CT7-2E1 SERVICE BULLETIN - 72-0030 R01

Revised:
04/28/2023

SB 72-0030 R01 ENGINE - COLD SECTION MODULE (72-30-00) - RELEASE OF
REDESIGNED COMPRESSOR CASE P/N 5168T76G05

REVISION 1 TO SERVICE BULLETIN 72-0030

Compressor Case
Figure 1

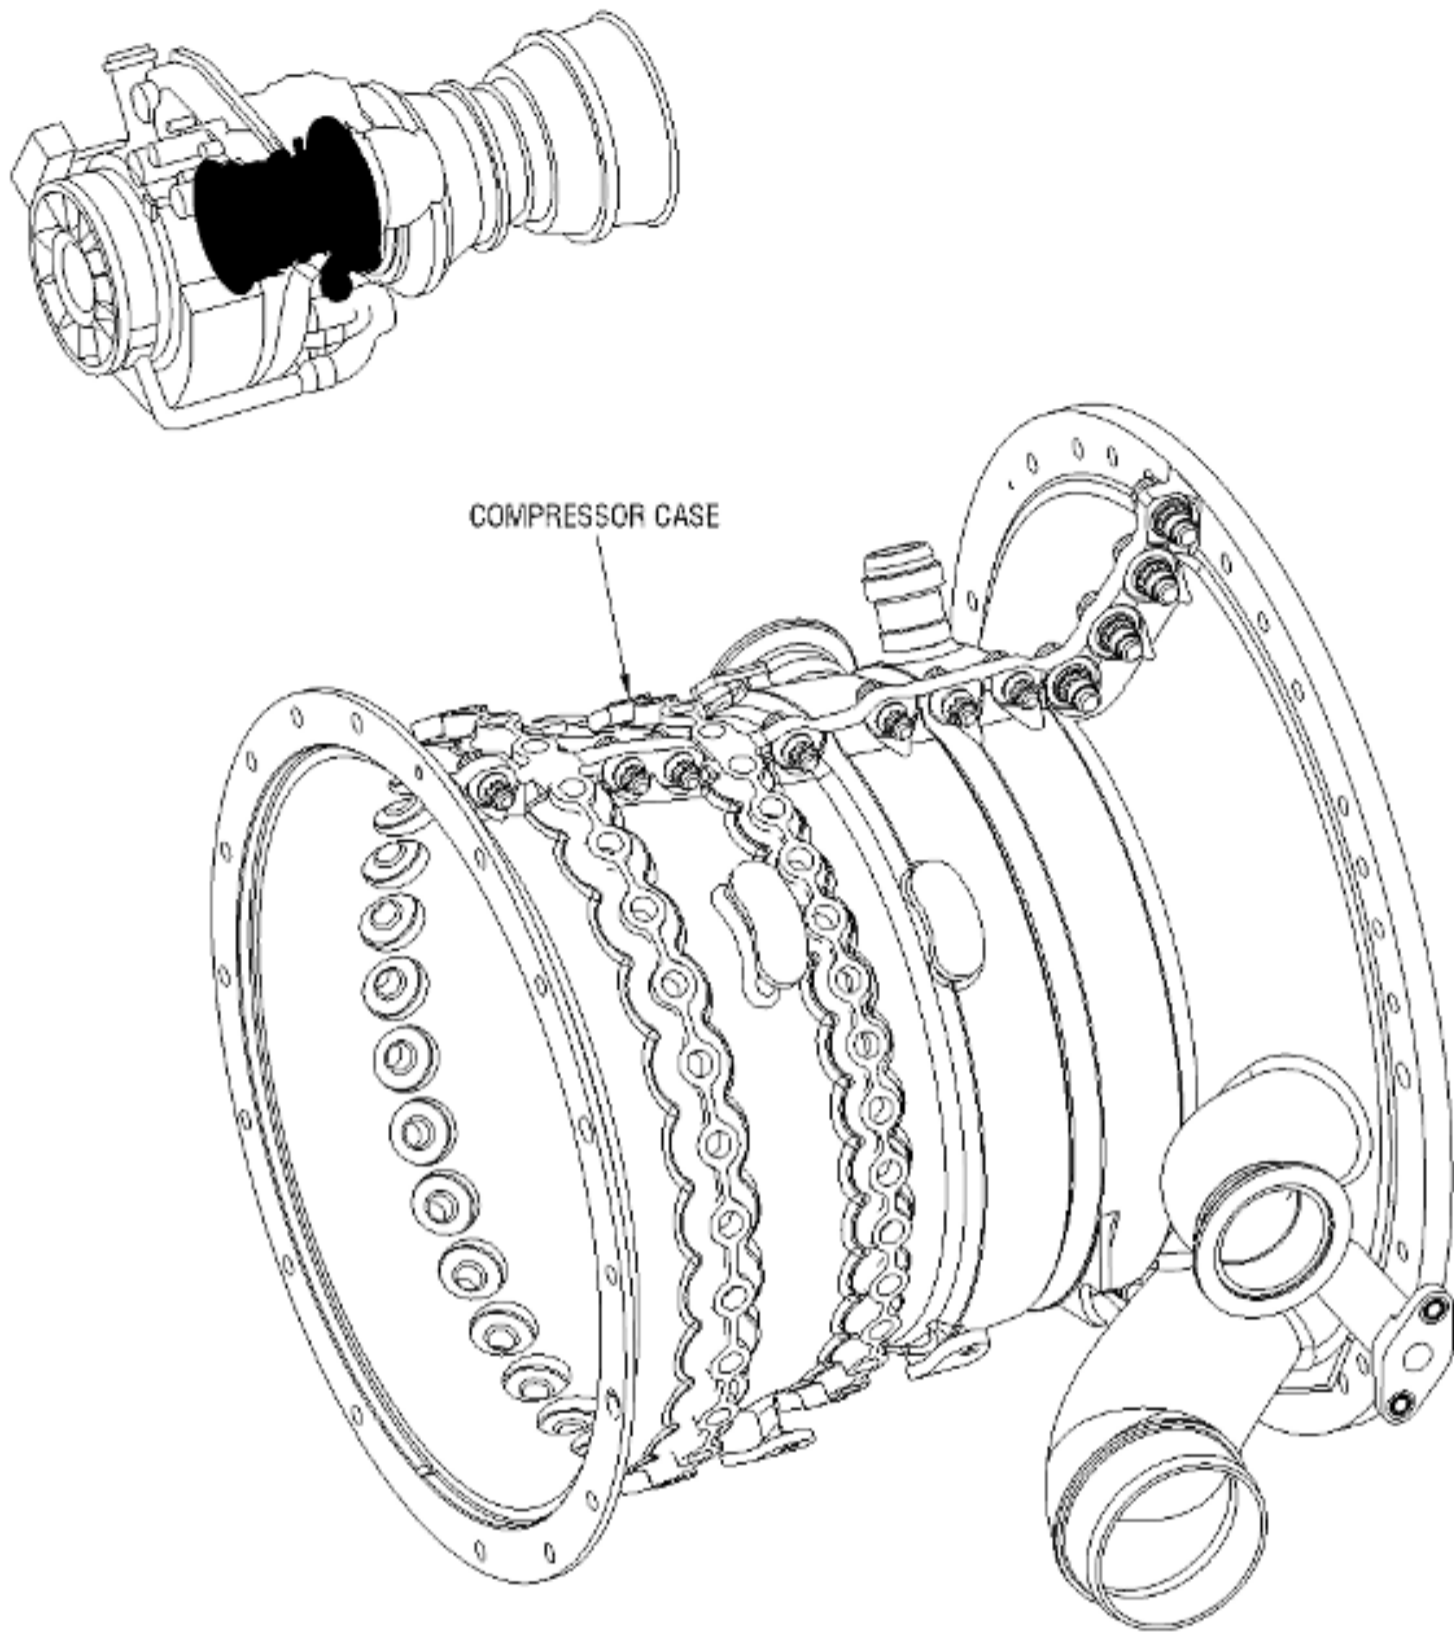
This Service Bulletin introduces compressor stator assembly P/N 6039T60G28 with a redesigned compressor case.

To replace the current compressor stator assembly P/N 6039T60G27 with a new compressor stator assembly P/N 6039T60G28 which uses redesigned compressor case P/N 5168T76G05 with improved life.

- (2) Condition:
Due to the geometry of the current compressor case split-line flange counterbores, component life is low.
- (3) Cause:
Compressor case P/N 5168T76G04 was certified with a life below the program requirement.
- (4) Improvement:
Updated cold section module with a new compressor stator assembly P/N 6039T60G28 assures that compressor case life will be improved.
- (5) Substantiation:
Substantiation is by analysis.

| New Part Number | Qty/ Eng | Part Name | Old Part Number/ IPC Location | Qty/ Eng | Op Code | Chg/ Sprt Code |
|-----------------|----------|--------------------------------------|--|----------|---------|----------------|
| ...5168T76G05 | (1) | Case, Compressor | ...5168T76G04 01-010,72-36-00 | (1) | RE | 1/B |
